# CUSTOMER ADVISORY

## ADV2002

### Label Content Update for FPGA and Power Products

**Table 2: Label Sample with "RoHS COMPLIANT"**

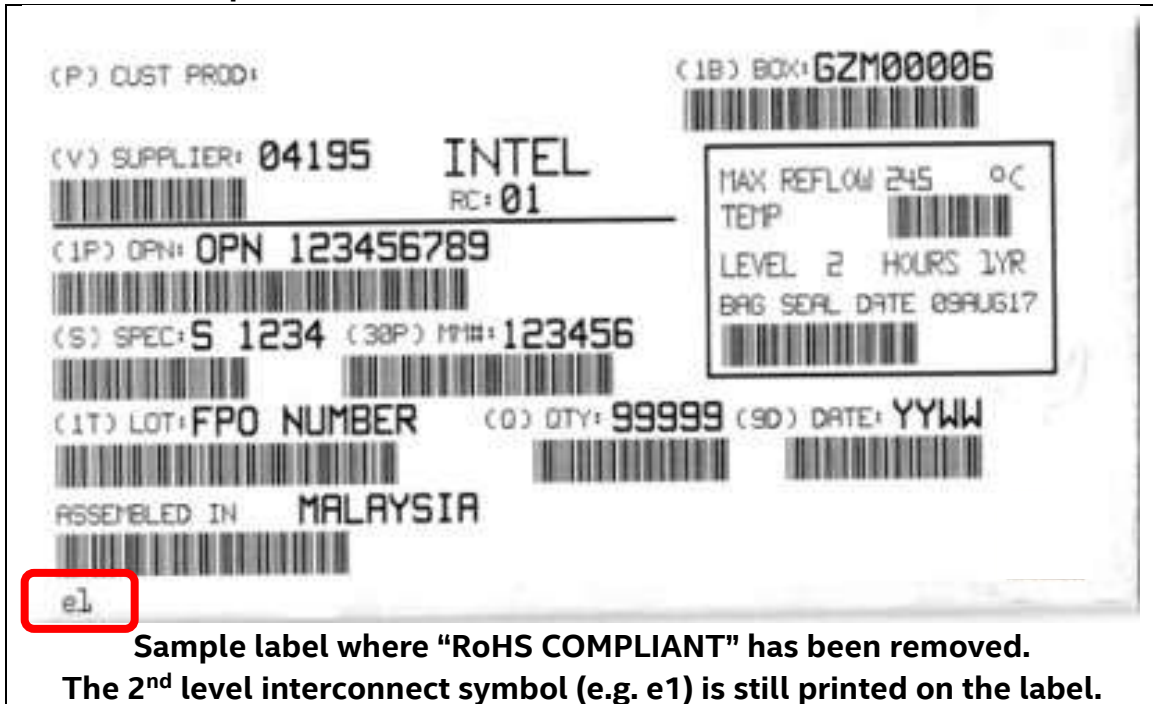
Change From	Change To
"RoHS COMPLIANT" indicated on the lower left of the barcode label	Labels may or may not indicate " <b>RoHS COMPLIANT</b> " on the barcode label.  The 2nd level interconnect symbol (e.g. e1) remains printed on the label.
